TCP/11/16(276)

Planning Application 11/01485/FLL - Erection of three wind turbines, Ardlebank Farm, Ballintuim, Blairgowrie, PH10 7NQ

SITE VISIT PHOTOS

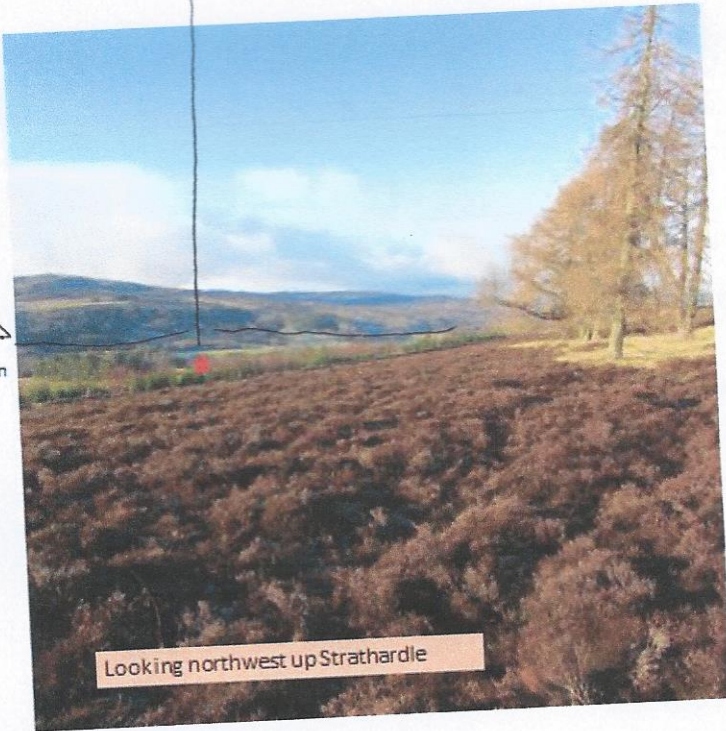
THINK OF THE HEIGHT OF THIS TURBINE

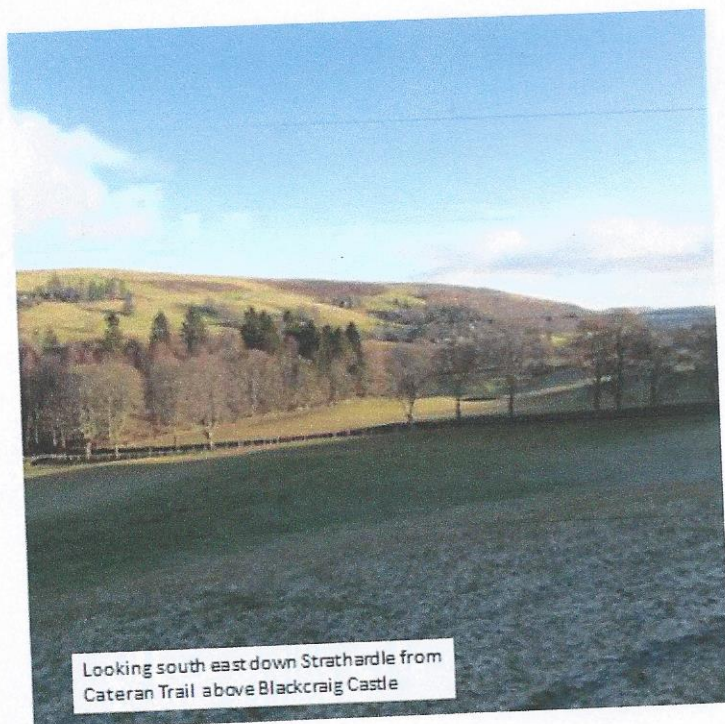
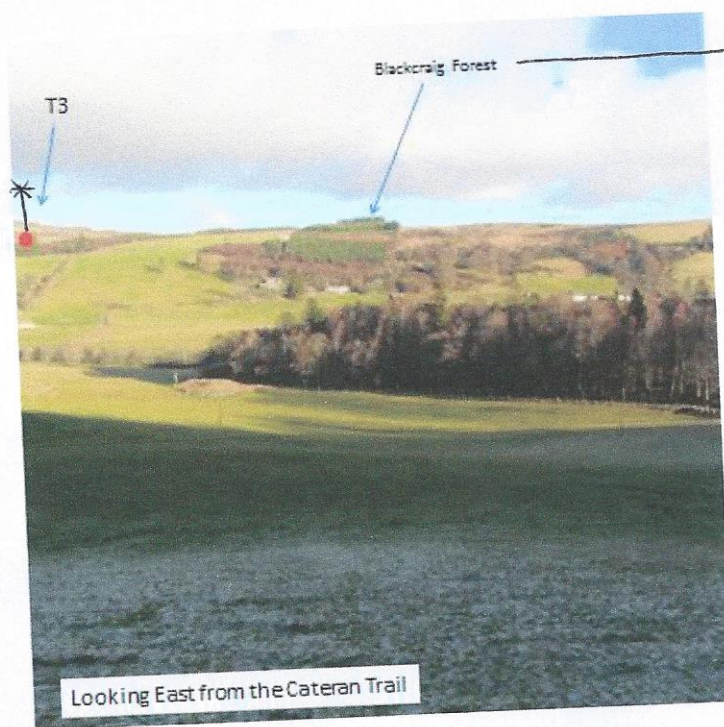
DONT FORGET
MR RICHARDSON HAS
9 MORE TURBINES
IN THE PIPELINE IF
PERMISSION IS GIVEN.
THEY WOULD DOMINATE
THIS SKYLINE

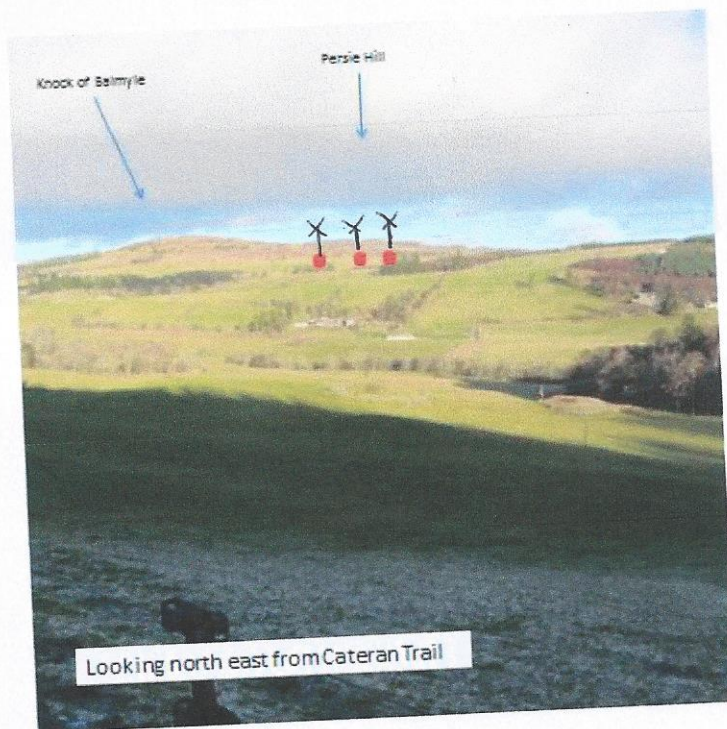
INCORRECT THIS IS
NOT BLACKCRAIG
FOREST IT IS
BEHIND THE PHOTOGRAPH

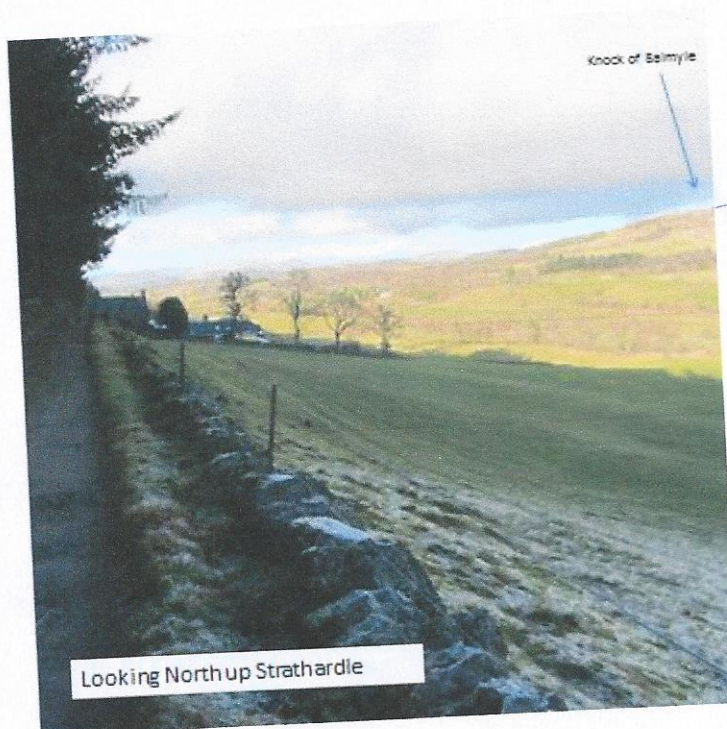
X ↑ X Turbines here.
